UNITED STATES PATENT AND TRADEMARK OFFICE

10/561,725

Office Action Summary	Application No. 10/561,725	Applicant(s) PEIN, ANDREAS	
	Examiner JONATHAN W. MILES	Art Unit 3731

DETAILED ACTION***Drawings***

Image 1 from Gernlein Fig. 2

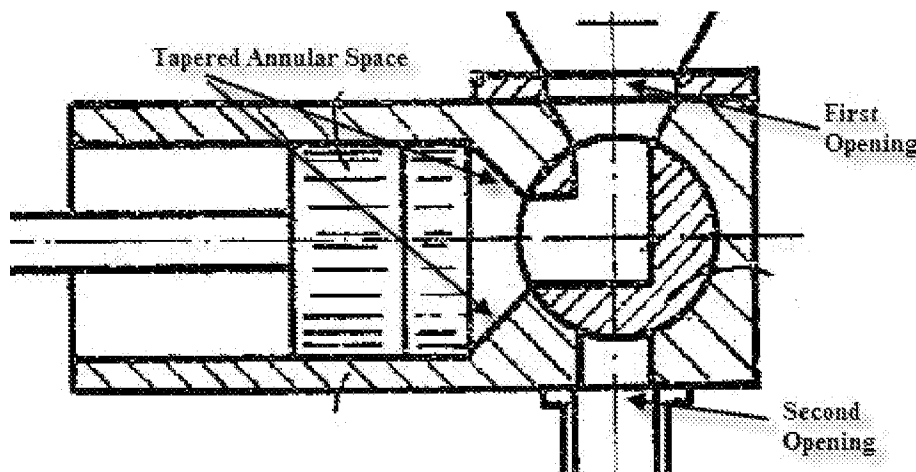
However, Gernlein discloses a fluid pump wherein the lowermost portion of the annular space tapers inwardly in a downward direction toward the suction-pressure space, the taper being formed by a frustoconical portion of the cylinder wall (see Image 1 above).

However Gernlein discloses a first and second openings being radially oriented and diametrically opposed with respect to the cylinder whereby the connecting device is installable in the first opening by initial insertion thereof through the second opening (see Image 1 above)..
